METROPOLITAN AREA PLANNING
DEPARTMENT

Re: S/D 94-18 KELLOGG WEST SQUARE ADDITION (Final Plat)

Reference: Kellogg West Square
Drainage

Reference: Kellogg West Square Addition
Cross Lot Drainage Agreement

**KELLOGG WEST SQUARE
 LOT 1, BLOCK 1
 EXISTING DRAINAGE
 AREA**

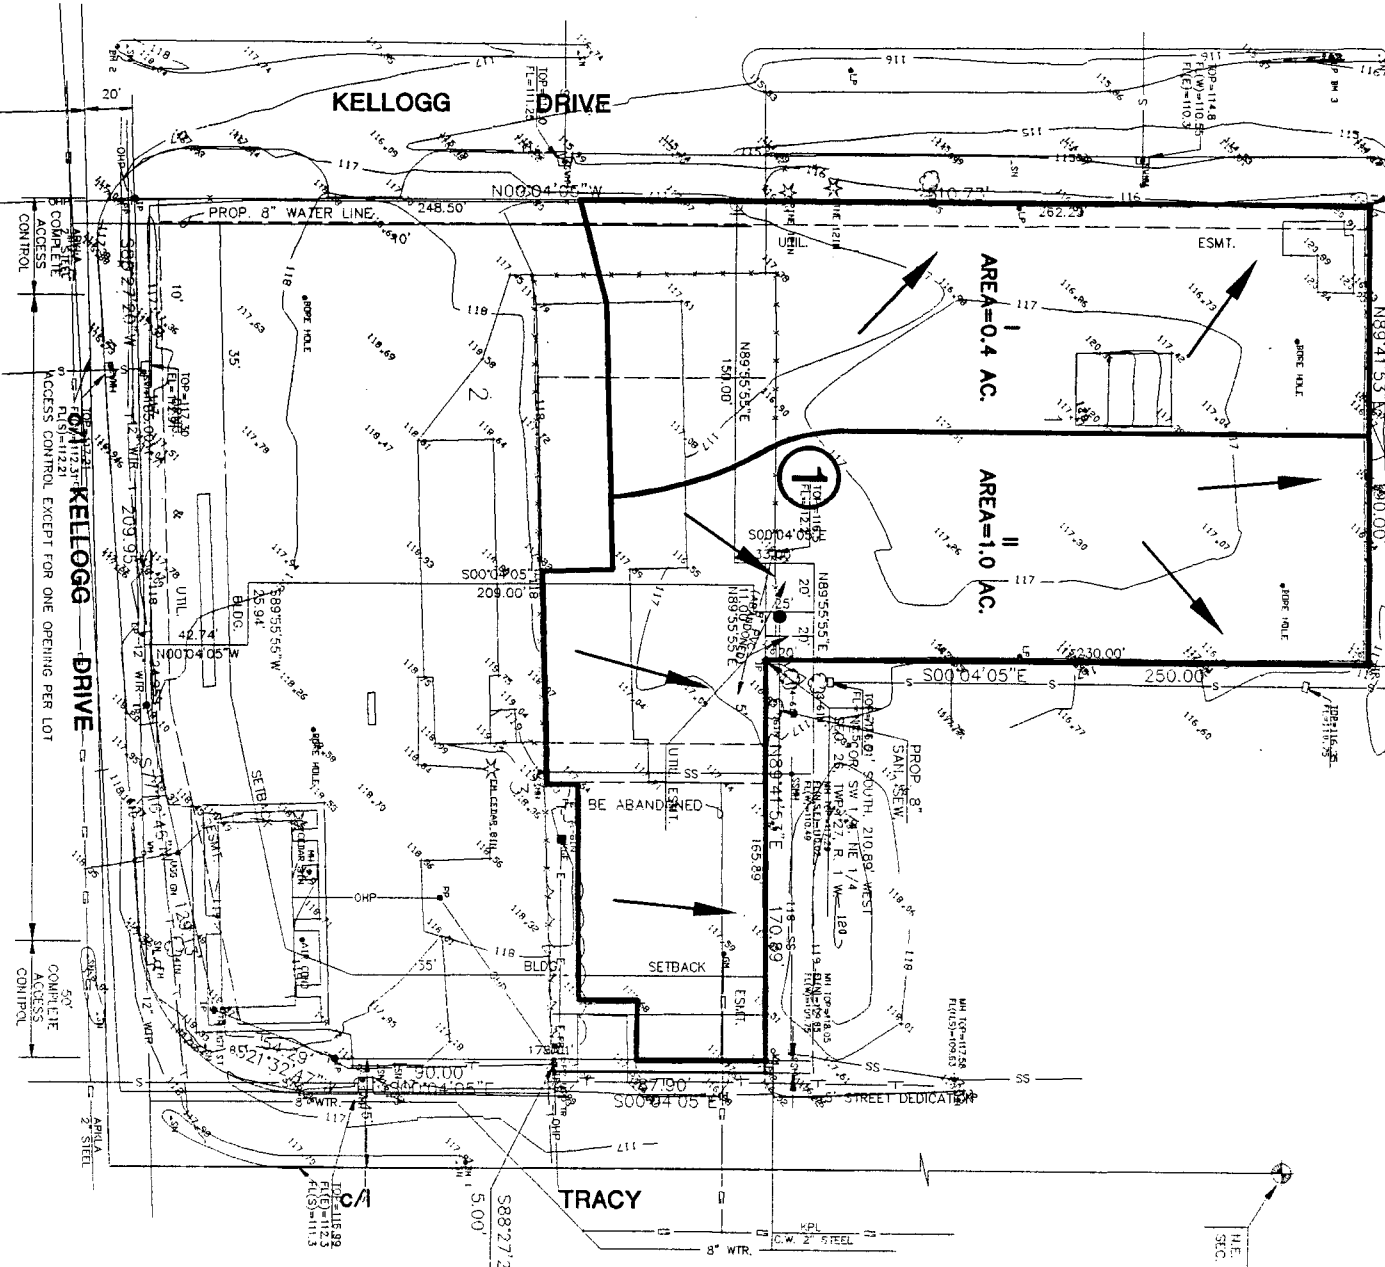
- K. As indicated by City Engineering, based on the drainage plan for this site, a cross-lot drainage agreement is required. Such an agreement shall be submitted to Engineering for review and approval and subsequently to Planning, with the final plat tracing, for recording.

I have done a drainage study of the Kellogg West Square Addition, as well as an overview study of the Town West site. The current drainage of the Kellogg West Square Addition indicates that approximately 1.7 acres of paved surface and roof runoff overland flows onto the Town West site. The proposed drainage of the Kellogg West Square Addition indicates that approximately 1.4 acres of paved surface and roof runoff will be captured in underground pipes and drain into the existing Town West system. Included is a letter from the City of Wichita, which verifies that the drainage area of Lot 1 Kellogg West Square has been decreased.

Lot 1 of Kellogg West Square Addition currently drains to Towne West property. Towne West property drains to a City system through the middle of the parking. The City system drains to a pump station which pumps to the Big Ditch. Lots 2 and 3 of Kellogg West Square Addition currently drain to Kellogg Dr. and then to the same pump station. Regardless of the direction that runoff from Lot 1 Kellogg West Square (through the Towne West system or Kellogg Drive system), it all ends up at the same location.

In conversation with the Chris Brietenstien, Public Works Engineer (Chris managed the storm water system for several years), the City system lacks inlet capacity, but has enough pipe capacity. In other words, the inlets are not big enough to get the water into the system, but the pipes could handle the water if the inlets were big enough. By putting the runoff from Lot 1, Kellogg West Square, underground on site, the ponding on the Towne West site will be reduce. The proposed grading of Lot 1 will incorporate on site ponding. The existing grading of Lot 1 has no storage capability.

1. The drainage area has been decreased.
2. Drainage will be underground, rather through undersized inlets.
3. Storage has been created on Lot 1, Kellogg West Square.
4. Drainage from Lot 1, Kellogg West Square will eventually flow to the pump station whether it drains to the Towne West or Kellogg Dr.
5. An Agreement should have been created at the time of the land exchange.
6. There is plenty of storage on Towne West per Towne West drainage Engineer

KELLOGG WEST SQUARE
LOT 1, BLOCK 1
PROPOSED DRAINAGE AREA

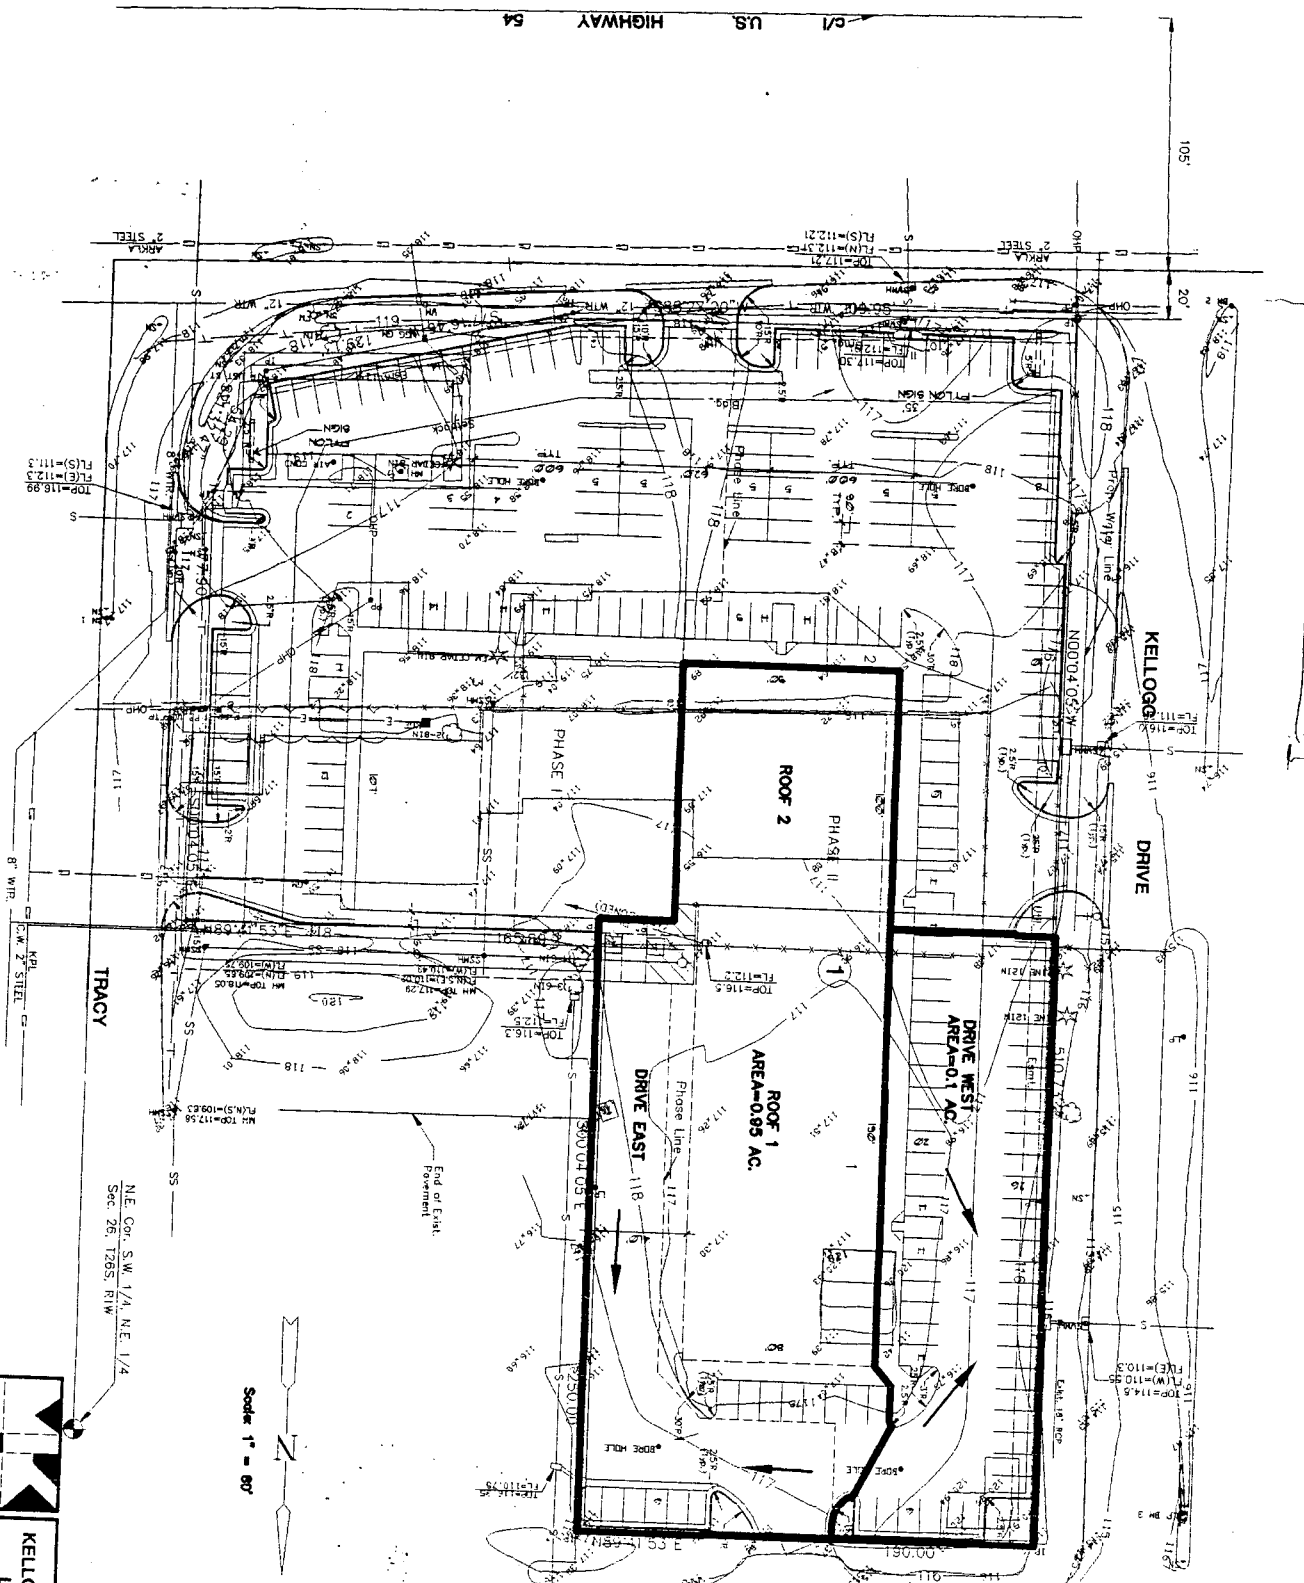
ORIGINAL	PROPOSED
WEST	0.70 AC.	0.40 AC.
EAST	1.00 AC.	1.30 AC.
TOTAL	1.70 AC.	1.70 AC.

This letter is to certify that the Drainage Plan and calculations provided by Mid Kansas Engineering Consultants, Inc. The indicated drainage areas to the Town West site from Lot 1, Block 1, Kellogg West Square have been decreased from 1.7 acres to 1.3 acres. The runoff from Lot 1 will decrease by 24% from the existing conditions.
